| Title | Action Item from Session #46: Consolidation of UCP – Uncoordinated Coexistence Protocol | |
| Re: | Working Group Letter Ballot #24 for IEEE P802.16h/D1. | |
| Abstract | This document contains proposed editorial and technical changes to sub clause 6.4.2.4 ‘ <i>Uncoordinated Coexistence Protocol (UCP)</i> ’ and associated sub clauses. A number of comments from Working Group Letter Ballot #24 considered at Session #46 are related to this clause. This document addresses these comments and suggests a harmonization of the comments presenting accompanying editorial instruction to implement the changes. | |

Figure h2a Flowchart showing generic operation **at the BS** in bands with **SSUs-specific spectrum users** [Note: revised figures]

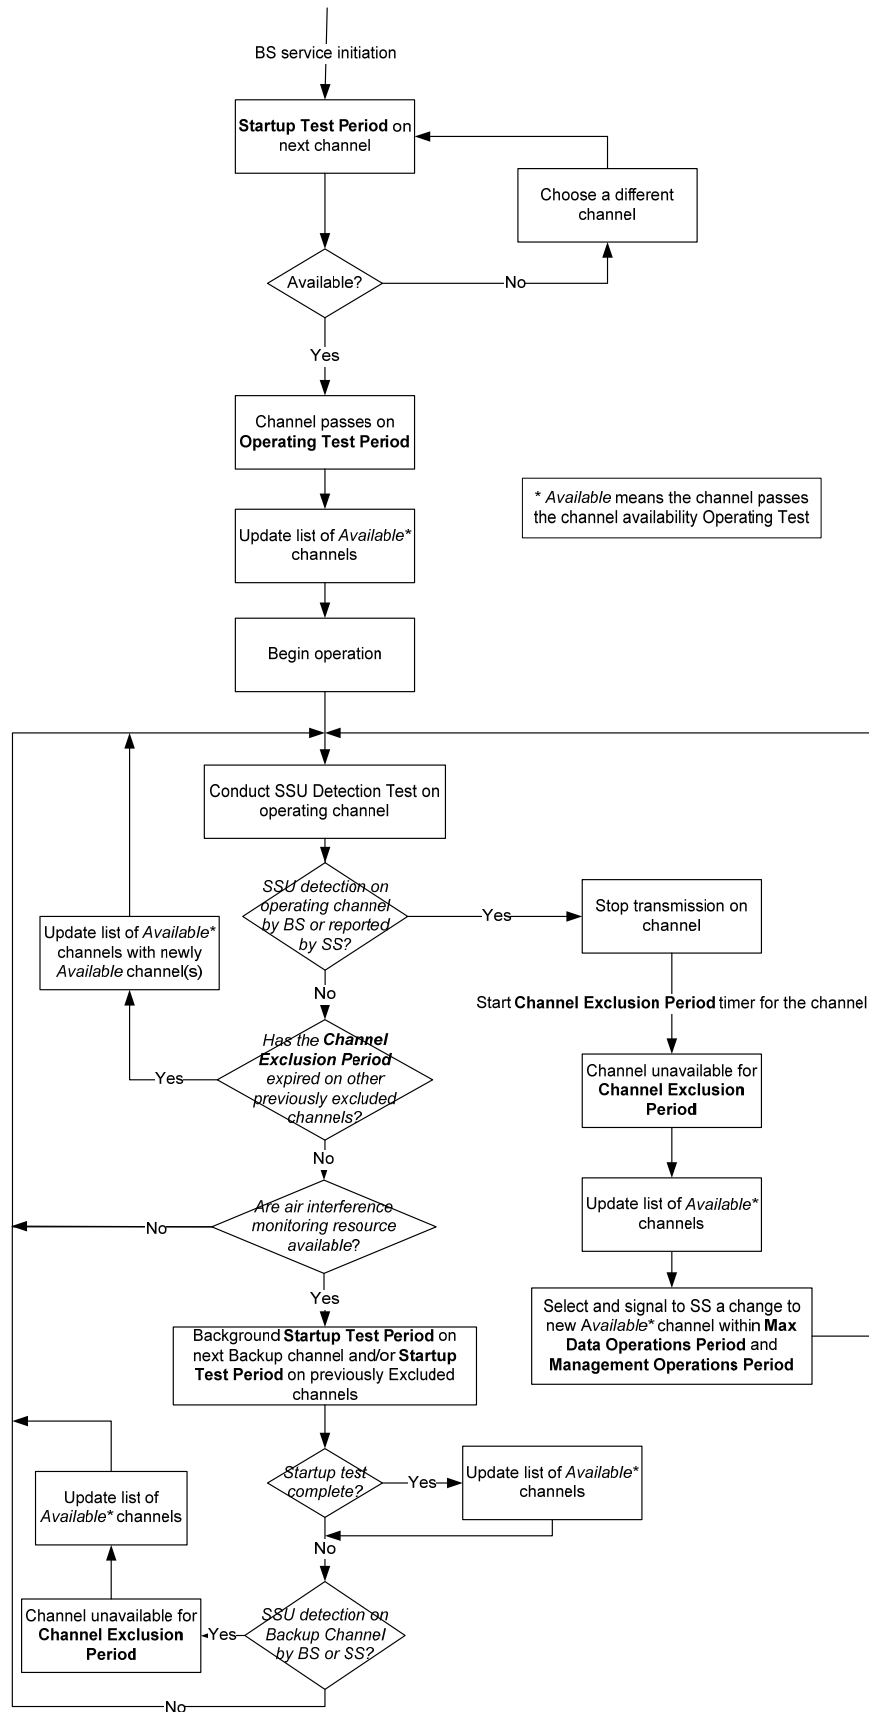
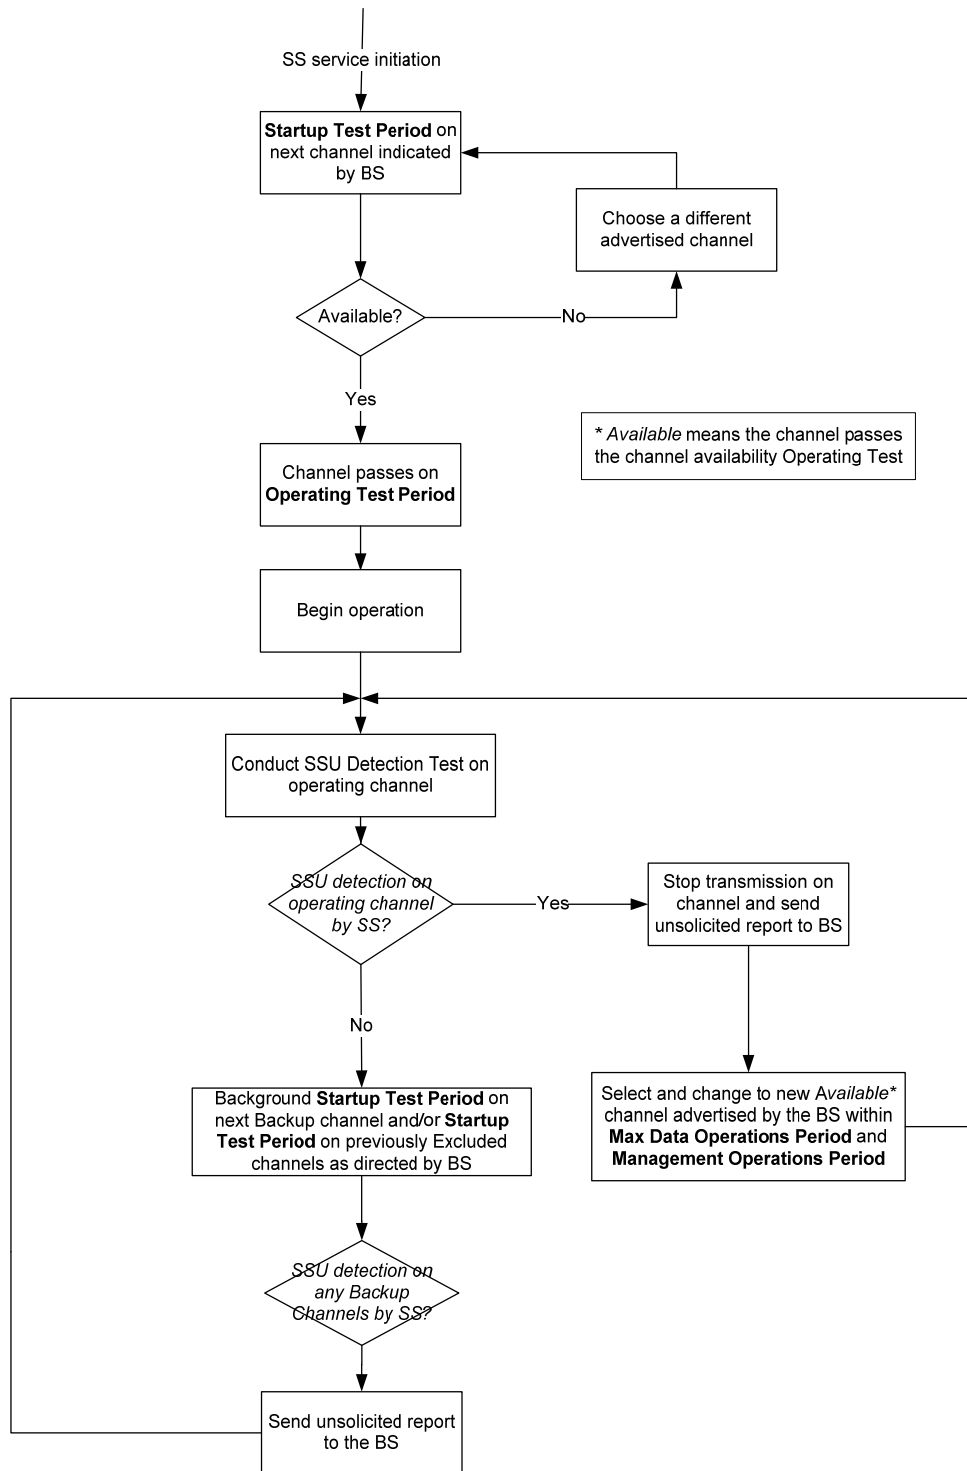
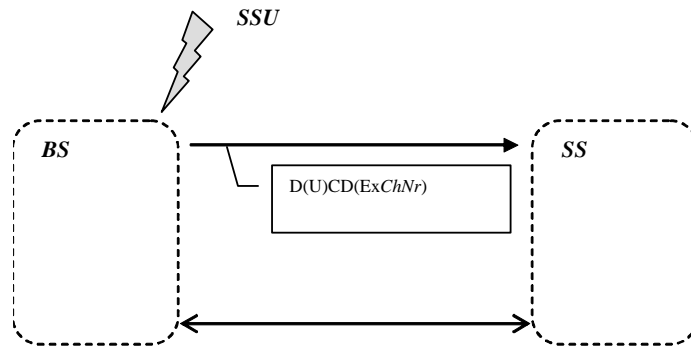
The coexistence mechanism described here should actually be implemented by both BS and SS. The diagram and the description miss the required operation when a "SSU" is detected by either the BS or SS. Namely the change to an alternative channel. In fact both BS and SS should scan the alternative channel constantly to ensure that the BS and any of the SS hasn't changed to that channel. If any SS or BS detect the interference they should immediately stop transmission, so they cannot notify any of the other parties about the change,

We should never get to the decision point "Channel Exclusion Period expired?" if the result would be false. The decision is in the wrong place in the flowchart. The timer can either be thought of as a separate parallel process (reality), or can be something that is periodically checked, in which case it should be part of the process of selecting a new channel in the box at the right-hand side around lines 46-48. Also, the starting of the channel exclusion period timer at line 36 is too simplistic because, as written, if any channel has an SSU detected then no channels are useable. Rather, there should be an independent exclusion timer for each channel on which an SSU is detected.

Add the following text and figure at the end of section 6.4.2.2.1.

Figure h2 provides an illustrative flowchart of a generic scheme for operation in bands with SSUs. The flowchart highlights the main operational requirements for coexistence and overviews the description in the remainder of this sub clause. [Figure h2a illustrates possible behavior at the BS, while Figure h2b illustrates the behavior at the SS. Figure hxyz1 provides a link level example of message exchange in the event an SSU is detected at \(a\) the BS, and \(b\) the SS.](#)

Fix the diagram to properly handle the exclusion timer. There are many ways to do this included what is described above.

Figure hxyz2a Flowchart showing generic operation at the BS in bands with non-SSUs only

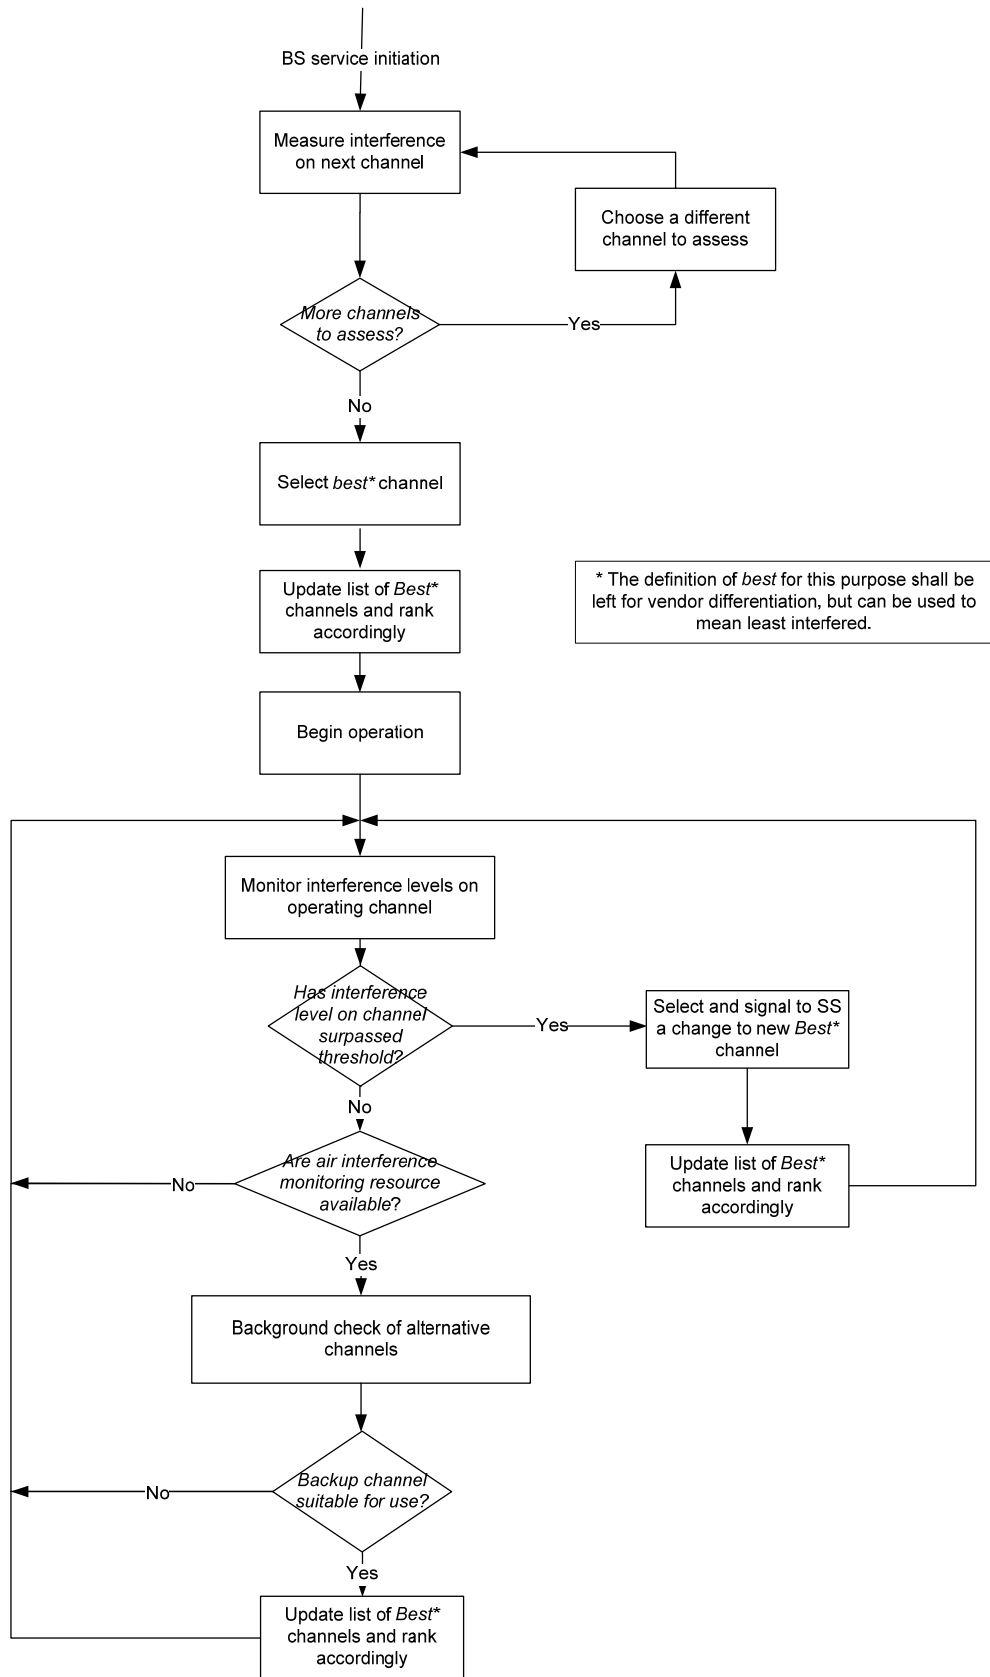
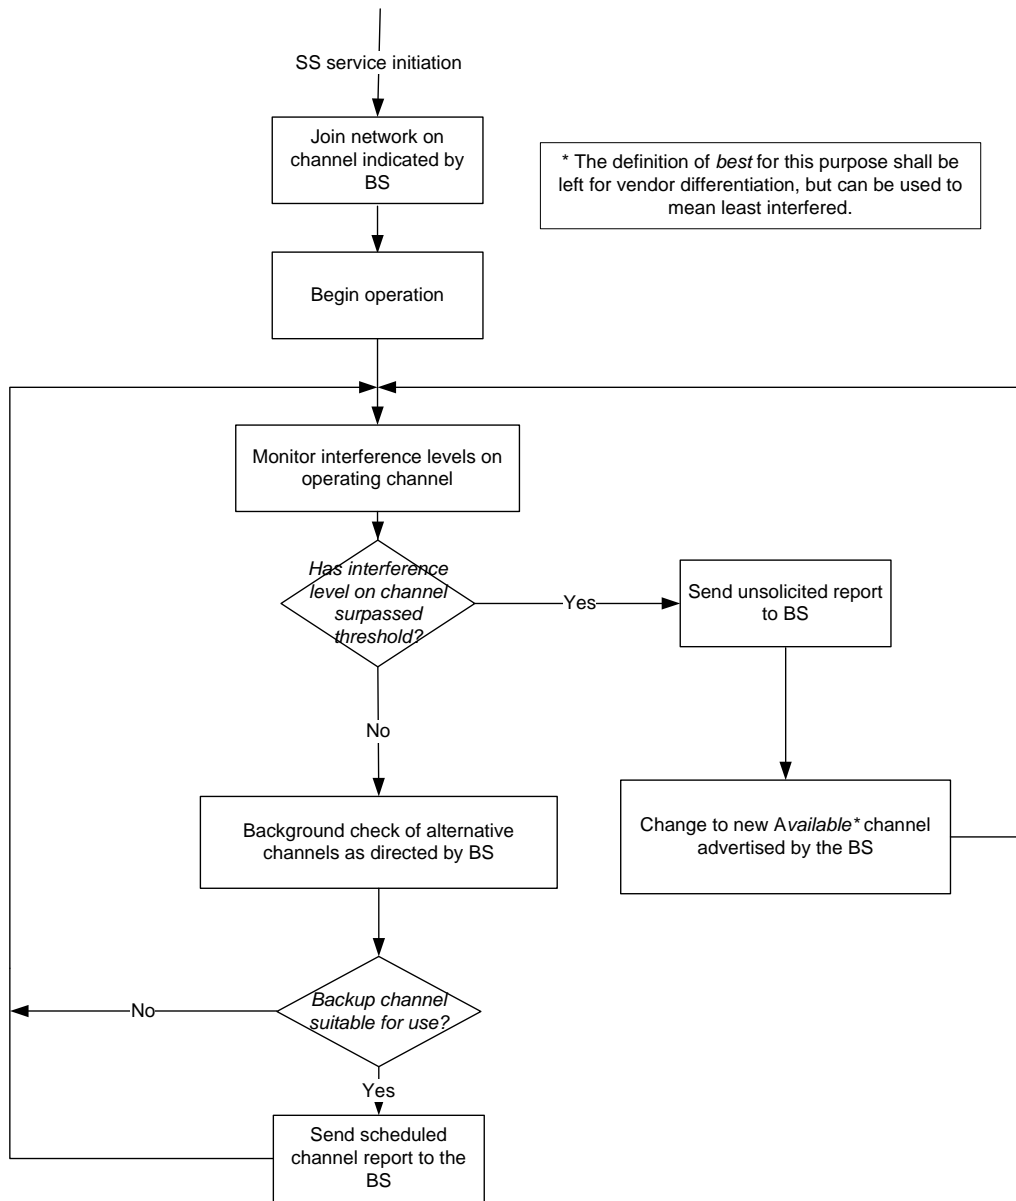
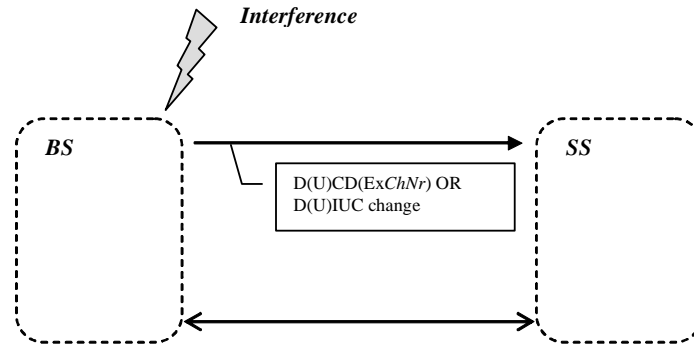
We need a true DCS mechanism - not a weakly hidden attempt at reiterating what's already in clause 15. That is to say, we need first a mechanism for choosing a physical channel. Once chosen, if a system wants to use the tools in clause 15 to time divide that physical channel into logical channels, it can. It was previously agreed that this section was to be combined with DFS (same thing, but SSU's). Instead, this section was expended to be redundant with the subframe concept of clause 15. This section should be rewritten appropriately.

Dynamic Channel Selection (DCS) is ~~a realization of~~ an uncoordinated coexistence mechanism and provides the ability for a system to switch to different logical physical frequency channel, based on channel measurement conditions, and ~~thus thereby~~ avoiding interference in non-exclusively assigned and non-exclusively licensed bands. ~~Logical channels can be constructed from an operating frequency and time component, or a portion thereof. Channel measurement and interference avoidance provide a DCS algorithm with the means of obtaining interference isolation in time and frequency. This approach enables a number of systems to share a given frequency. The approach contrasts to that of subclause 6.4.2.2., which specifies SSUs avoidance in which the physical frequency is vacated due to the potential interference to the SSU.~~ DCS can be used as a means of finding a least interfered channel at system startup or can be used during normal system operation to provide constant interference monitoring capabilities and, with the ability to monitor other channels, provide a list of backup channels for informed switchover to a different, less interfered, channel. An illustrative example is given in Figure hxyz2a for possible behavior at the BS, while Figure hxyz2b illustrates the behavior at the SS.

The flowchart given in h1 (6.4.2.2) may be used to maintain a list of available backup channels for use in the event interference is detected on a channel and needs vacating due to high levels of interference.

Figure h7—~~listen-before-talk~~LBT [Note: revised figure]

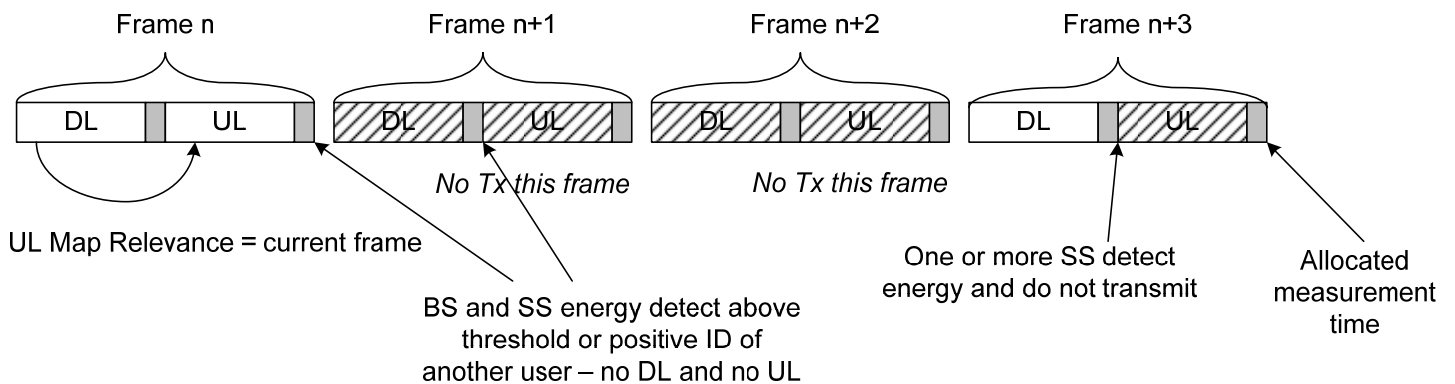
The proposed mechanism violates the OFDM and OFDMA Frame structure, by introducing silence periods at and eliminating preambles, FCH, MAPs etc.

The proposed mechanism violates the coexistence rules established between 802.16h users, as the interference-free periods provided by the Master sub-frames

The proposed mechanism violates the OFDM and OFDMA Frame structure, by introducing silence periods at and eliminating preambles, FCH, MAPs etc. LBT does not violate OFDM/OFDMA frame structure. It is right and proper to introduce quiet periods and make interference assessment by way of *channel measurement IE* (8.4.5.3.5). Preambles, FCH and MAPs are still present.

The proposed mechanism violates the coexistence rules established between 802.16h users, as the interference-free periods provided by the Master sub-frames: There is no violation for coexistence rules between 802.16h users. There is nothing that requires WirelessMAN-CX systems to implement LBT. It seems from previous discussion that aEQP and LBT is a means of facilitating WirelessMAN-CX systems.

When attempting to coexist with certain non-802.16 users of non-exclusively assigned or non-exclusively licensed bands, EQPs may not be sufficient. In these cases, a ~~listen-before-talk~~LBT protocol must be used. In such bands, the BS shall operate with a UL-MAP relevance of the current frame. This allows the DL and UL subframes to be logically viewed as a single “packet” of constant duration equal to the frame duration. The BS shall allocate ~~the UL subframe such that a time period is reserved between the end of UL allocations and the start of the frame preamble for the next DL subframe as shown~~part of the DL subframe as an opportunity for an SS to measure and report on the current state of the channel, and provide input to the LBT protocol. An Extended Channel Measurement IE (see for example sub clause 8.4.5.3.5) may be used, along with a gap in DL transmission, to provide such an opportunity. In a similar way part of the UL subframe may be reserved from SS transmission for the BS to make measurements on the current state of the channel and update the LBT protocol accordingly. Given that the LBT protocol detects energy above the defined threshold then no transmission will take place in the succeeding subframe. In the event there is no downlink transmissions then the SS will apply the last received DL-MAP/UL-MAP over the period of no transmission. The use of the LBT protocol shall recognize appropriate use of the Lost DL/UL MAP Interval parameter in table 342. Transmission recommences when energy levels drop below the threshold level. Due to the fact that there may be no time to signal an energy detection event then a BS or SS shall reliably handle the absence of a subframe where it was previously scheduled by the DL or UL-MAP. An example of this arrangement is given in Figure h 7. This time period shall be used to sense other non-802.16 systems and shall have at least the durations specified in Table h 2. The minimum LBT duration is determined from the CCA (Clear Channel Assessment) duration of 802.11. The actual LBT duration may be longer than these values based on the inter-frame behavior of 802.11 and the CCA requirements of different 802.11 variants. Specific implementation of this protocol is not specified and is left for vendor differentiation. Use of ~~listen-before-talk~~LBT shall not eliminate any requirements for other measurement and reporting that may be required for operation in a particular mode or band. Use of listen-before-talk shall not eliminate any requirement for use of EQPs.
